Chassis ID	Path
	260/Parts/Technical service bulletins/Service
Model	Identity
MD7 BE	198114621
Publish date	ID/Operation
8/6/2026	M-261-009

Bracket, Cooling Box, Modification

M-261-009

All Mack MD electric trucks

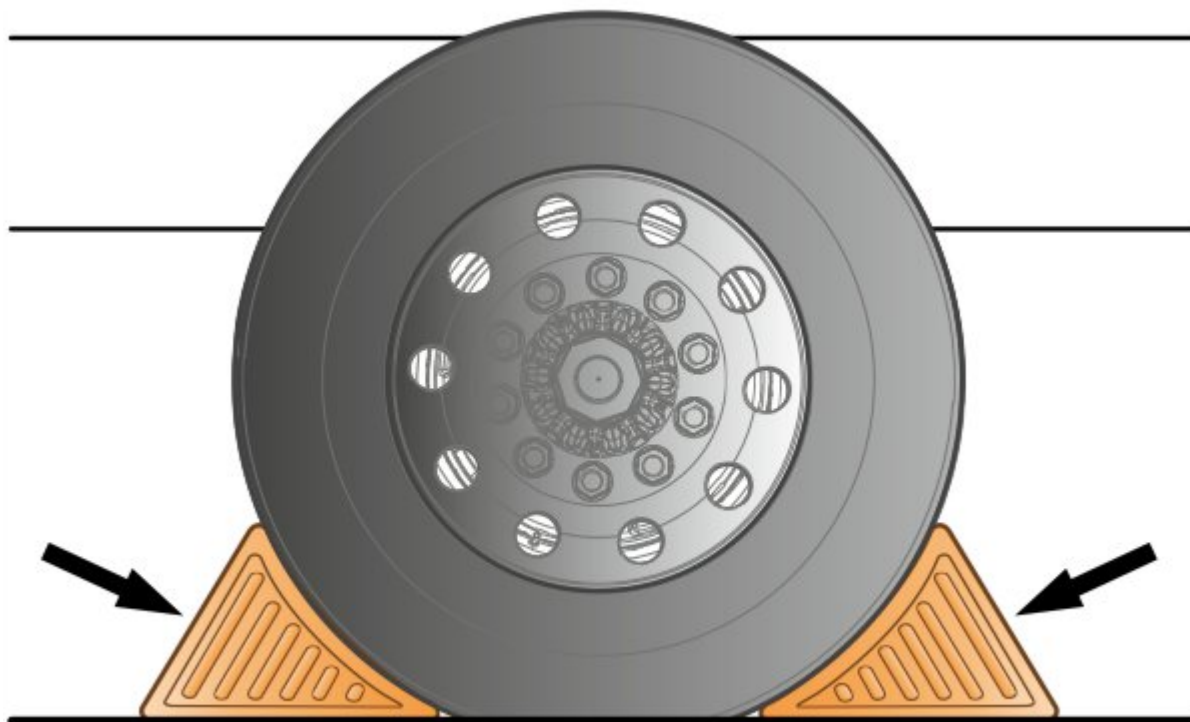
The current MD electric cooling box mounting blocks access to the radiator drain. This procedure gives the instructions to gain access to the radiator drain.

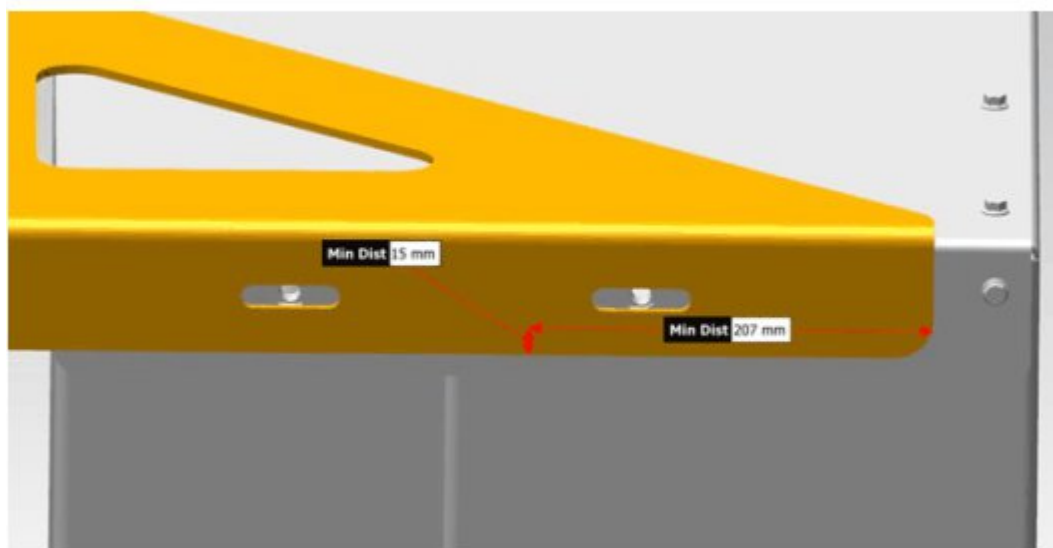
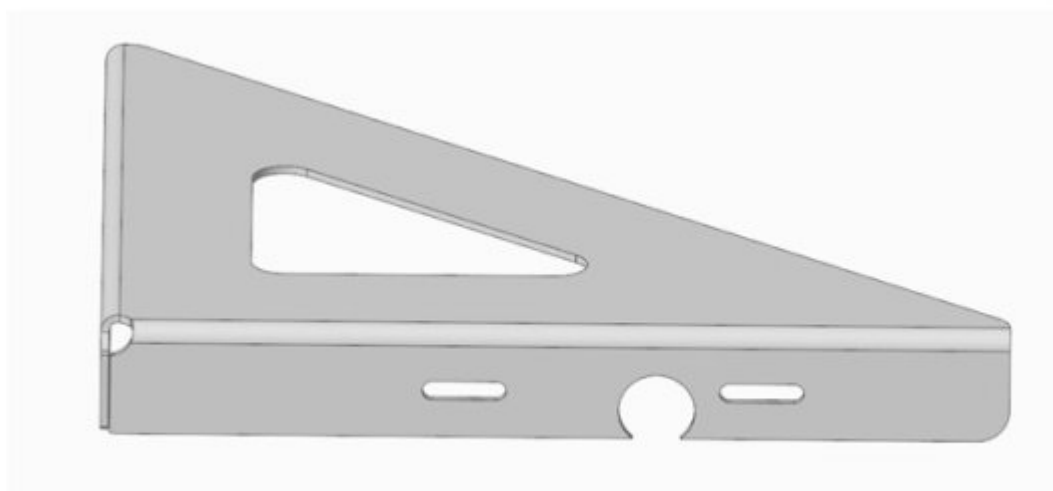
8. Cut a 40 mm diameter access hole at the location specified below.

Note: Measurements are approximate as cooling box location can differ due to production variances. Ensure the hole cut corresponds with the hole in the cooling box for drain access.

Note: A square notch ending no more than 40 mm from the edge of the flange is acceptable.

Note: Measure 207 mm from the outboard bottom edge of the bracket toward the inboard side of the truck. From this point, measure 15 mm toward the front of the truck. Mark this point as the pilot mark.
